AGENDA MEMORANDUM

Planning Commission Meeting of August 10, 2022

Azali Estates Unit 3

Request for a plat waiver for One Way Cycle Track Construction (both sides)
in Section 3.8.3.C of the Unified Development Code

Exhibit A

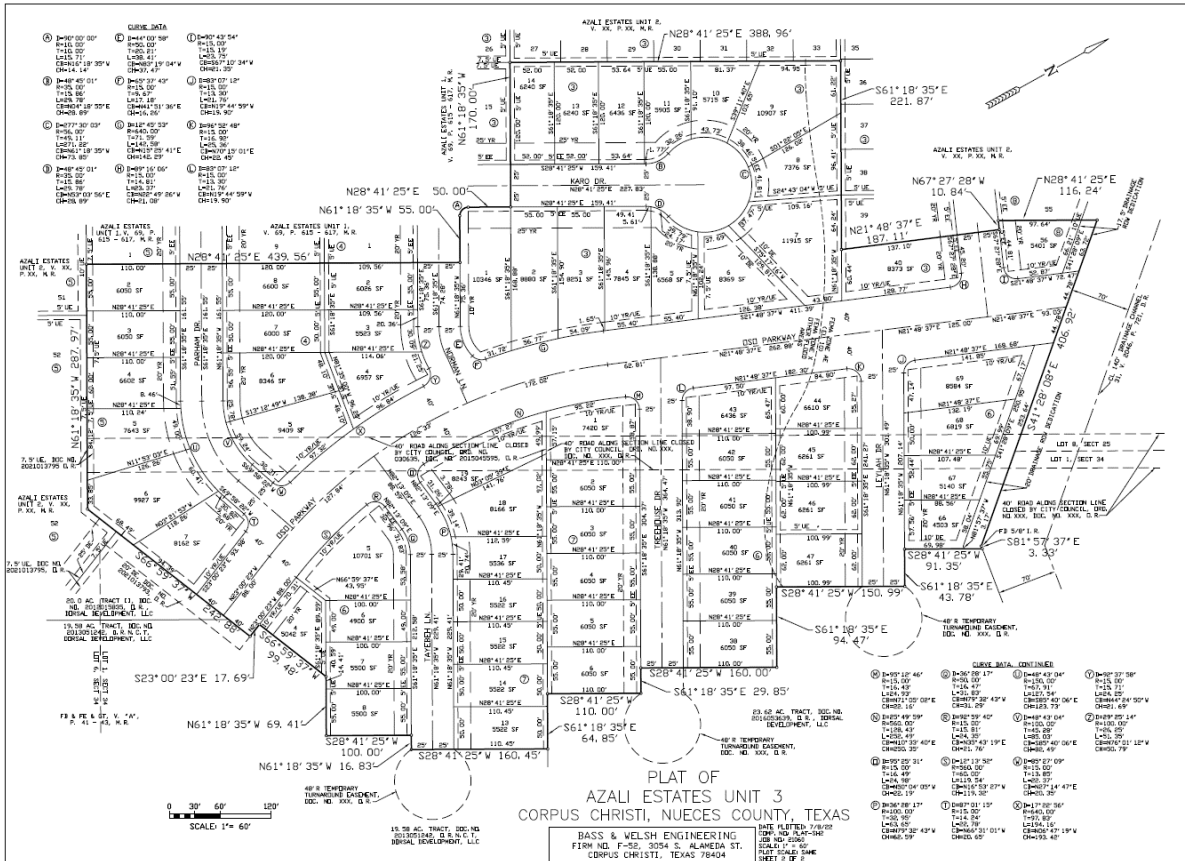
A One-way Cycle Track (both sides) would require 11' walkway path on both sides of the collector in lieu of a 5- sidewalk on one side and an 8' sidewalk on the other side of the street. **The waiver request** is to build a 10' walkway/path on one side and a 5' sidewalk on the other side of the 1,420' One-Way Cycle Track (both sides) running through the middle of the development to Channel 31.

1. UDC Section 3.8.3.C.2 states that the preliminary plat is consistent with the Comprehensive Plan, Utility Master Plans and any other adopted plans. **This includes the Bicycle Mobility Plan.**

2. The One-Way Cycle Track is clearly defined on the Bicycle Mobility Plan. Not building these tracks will remove the connectivity of bicycle network and future construction of a quarter of a mile that is part of the trail.

3. Building these tracks will promote future pedestrian and bicycle traffic as the area grows. **Azalli Estates Unit 3 plat indicates that there are 59 lots that will be developed.** This development along with the current and the rest of the future Azalli Estates development phases will generate pedestrian and bicycle traffic.

4. The properties along the proposed One-Way Cycle Track from Drainage Channel 31 to Yorktown Blvd. are unplatted, so an approximately 3000' in length One-Way Bicycle Track (both sides) can be constructed as properties plat. Yorktown Blvd. from Rodd Field Road to the Oso Creek bridge is a CIP project under design.

6. The 80' street right of way provides sufficient space for the track (both sides).
7. This project could be eligible for city participation funds UDC 8.4.1.C

- **Disapproval of the waiver** request to deviate from the One- Way Cycle Track (both sides) street standard and reduce the size of the 10' walkway/path to 5' on one side of the street.
